# Memorandum

**RE:** **P.Z. 08-2017 Brite Worx Carwash (Wallis Companies):** A request for a zoning map amendment from a "PC" Planned Commercial District to a new "PC" Planned Commercial District for 1.8 acres located on the western corner of the intersection of Baxter Road and Clayton Road. (21R410960).

## Planning Commission Staff Report

**Petition:** **P.Z. 08-2017 Brite Worx Carwash (Wallis Companies)**: A request for a zoning map amendment from a “PC” Planned Commercial District to a new “PC” Planned Commercial District for 1.8 acres located on the western corner of the intersection of Baxter Road and Clayton Road. (21R410960).

DRAWING NO.: **C200**  
 SHEET 04 OF 06

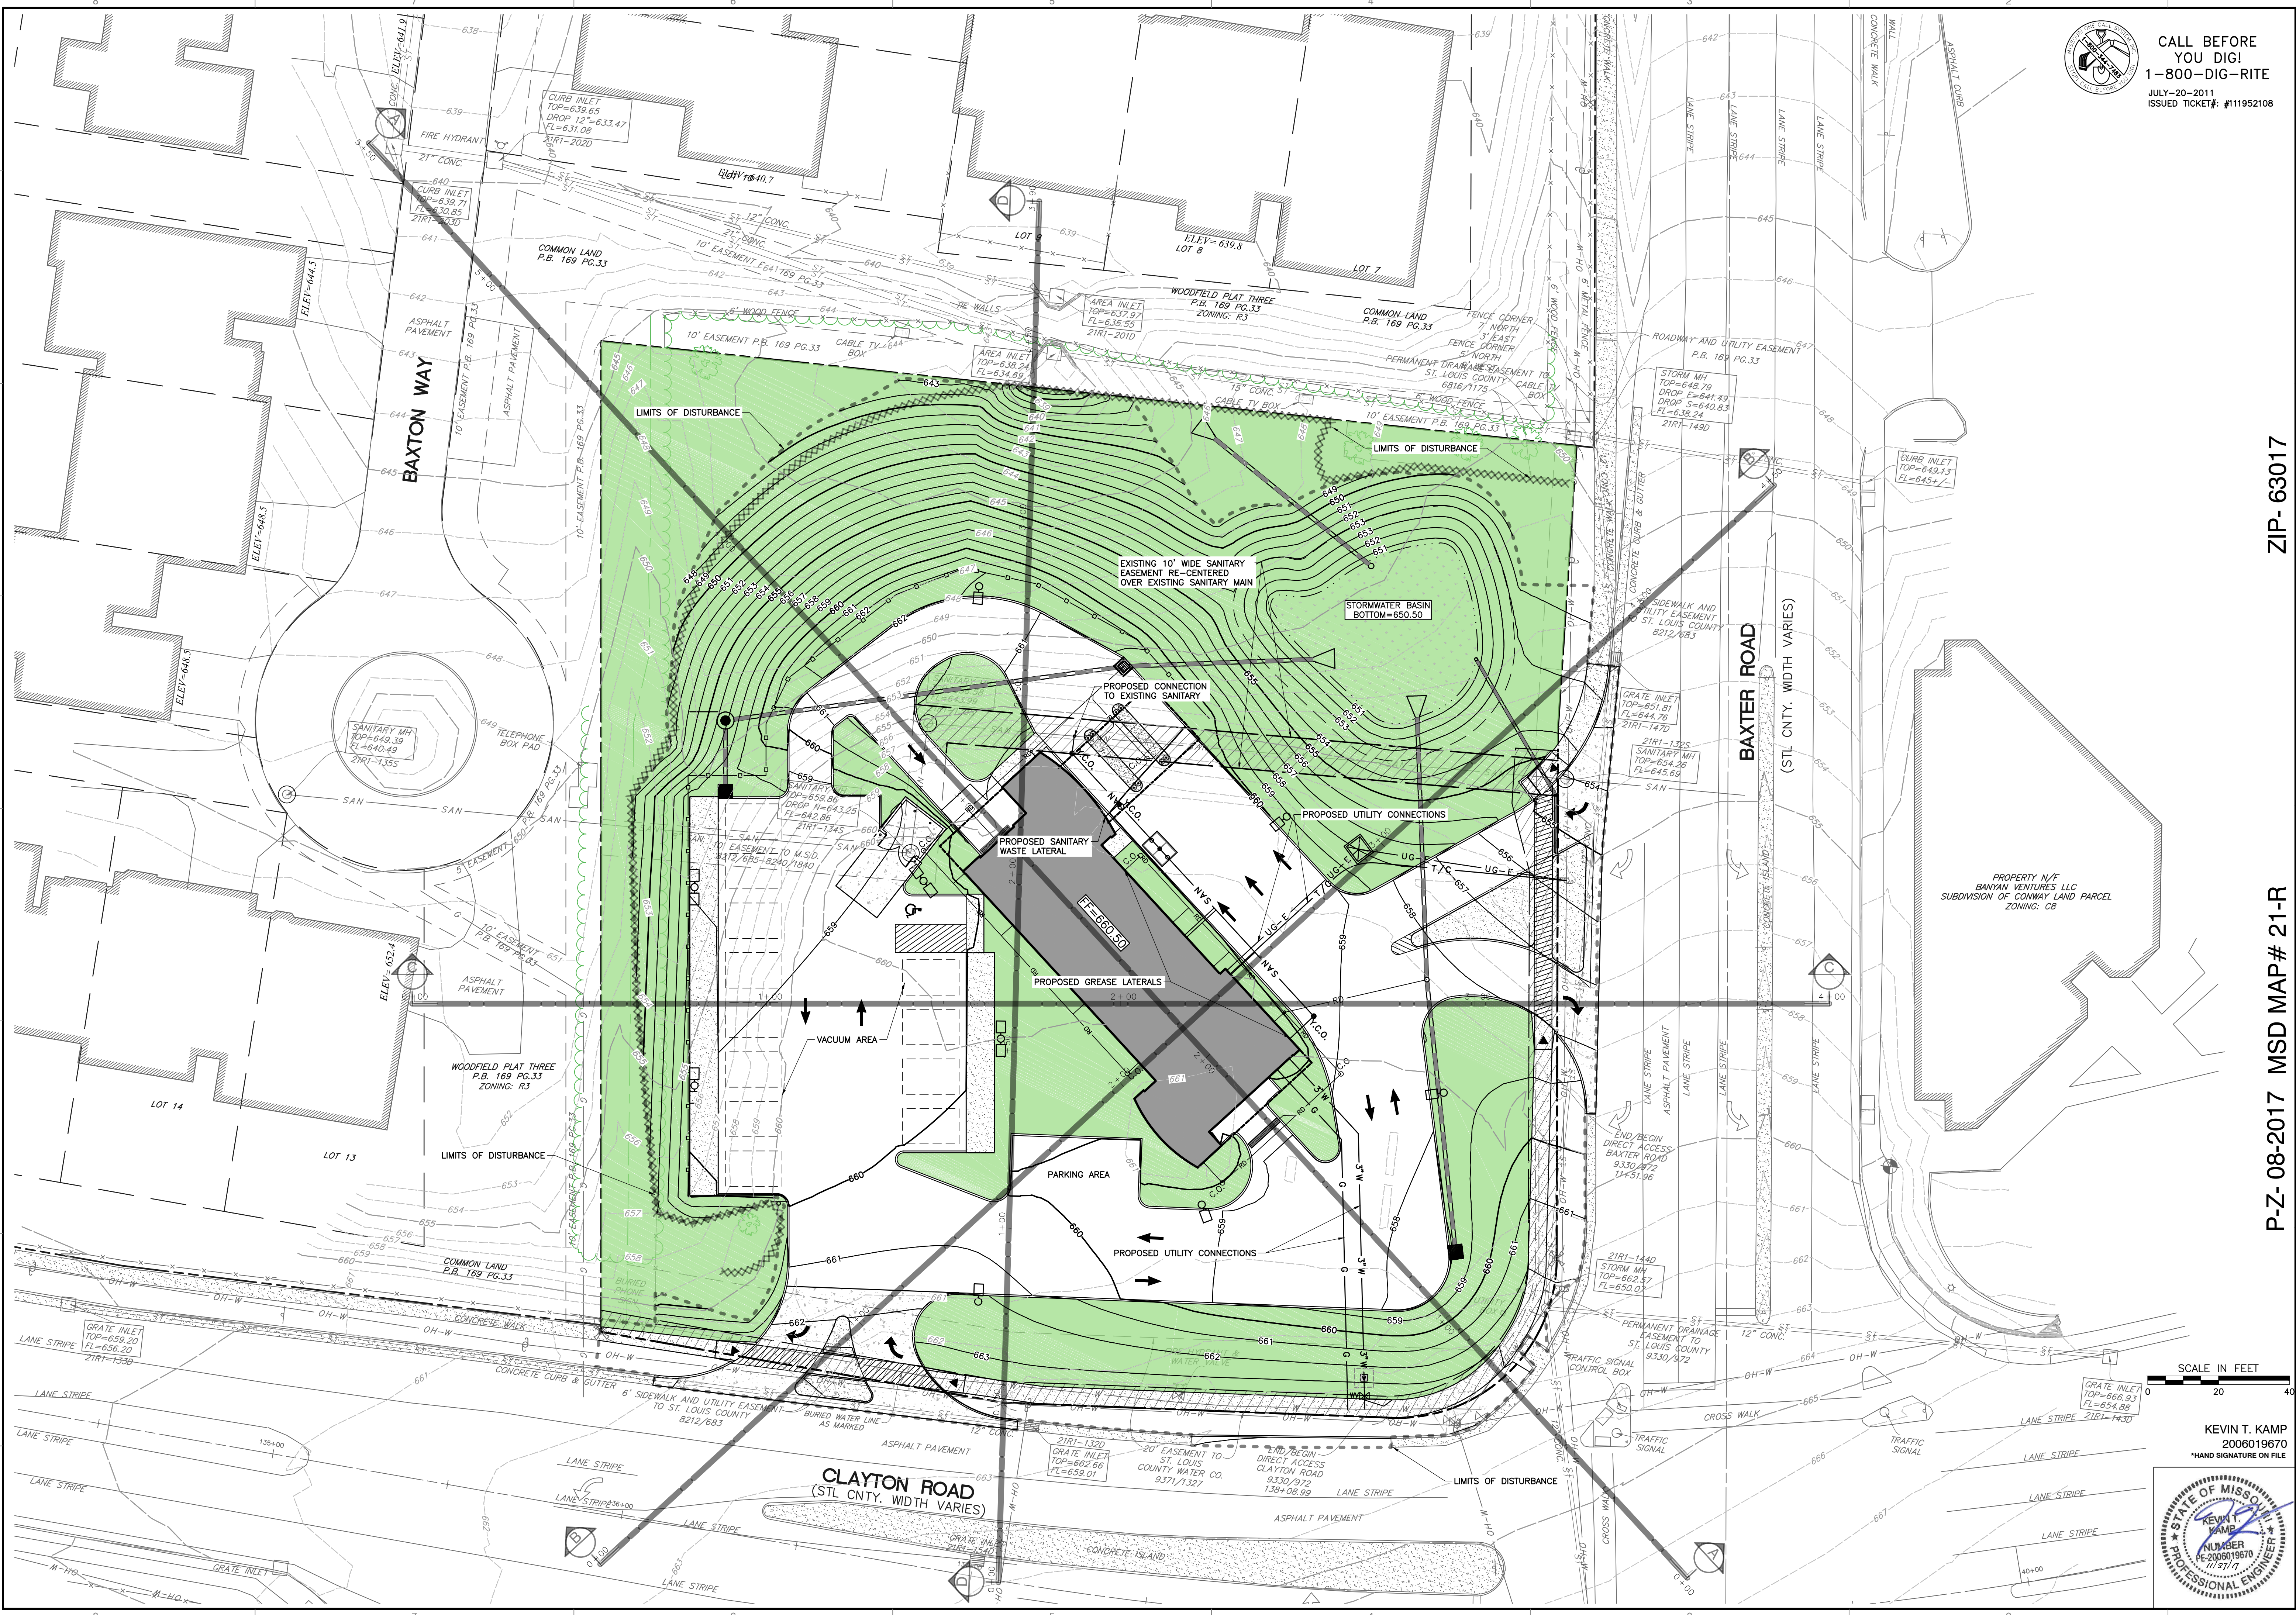
7	<p><i>Comment: During the meeting, lowering the height of the tower elements was mentioned, please revise section plans to include a revised height.</i></p> <p><b>Response: The height of the tallest tower has been revised to be height of 25'(max.). The specific architecture will be further refined and adjusted as needed during the Site Development Plan phase.</b></p>
8	<p><i>Comment: Provide a clear comparison of the existing conditions, approved renovation, and proposed plan.</i></p> <p><b>Response: The plans have been revised to provide a comparison of the existing conditions, the approved redevelopment plan, and the proposed plan. (see C200)</b></p>
